Reference: Tanglewood Major Subdivision Candia Tax Map 414 Lot 152

In accordance with the request of the Town of Candia, NH Land Use Office we have reviewed the following information submitted by Eric C. Mitchell and Associates Inc. (ECM Inc.) for the above referenced project received on April 28, 2021 with a notice to proceed, for the review, dated May 5, 2021:

- Subdivision Plan entitled Tanglewood Subdivision (previously submitted as Crowley Woods), prepared by Eric Mitchell & Associates, Inc., 17 plan sheets, dated March 24, 2021.
- Major Subdivision Application with attachments, prepared by ECM Inc., dated April 22, 2021

See attached map for reference.

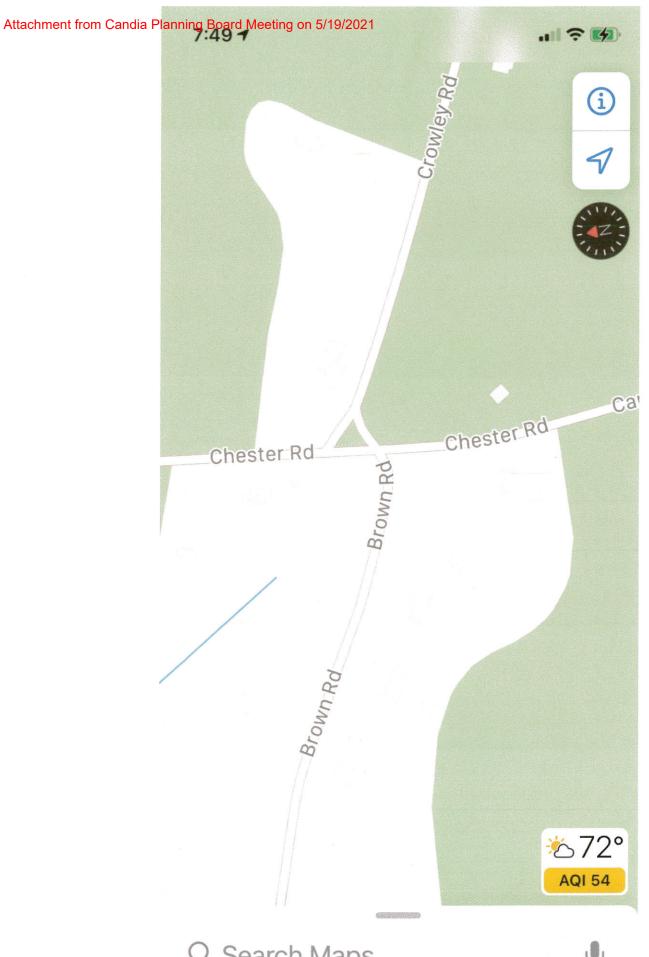
As you can see, Brown Road will serve as another access route onto Crowley Road (as it does today). Our concern is that Brown Road has not been discussed or evaluated (that we could see) for traffic impact should this project move forward.

We are appealing to the board to require a full evaluation of Brown Road and how it would need to be improved in order to support the additional traffic a large housing development will create. Today Brown Road is a lovely country road that is narrow and curvy throughout most of the road. It has stone walls, wetlands, and swamps to consider.
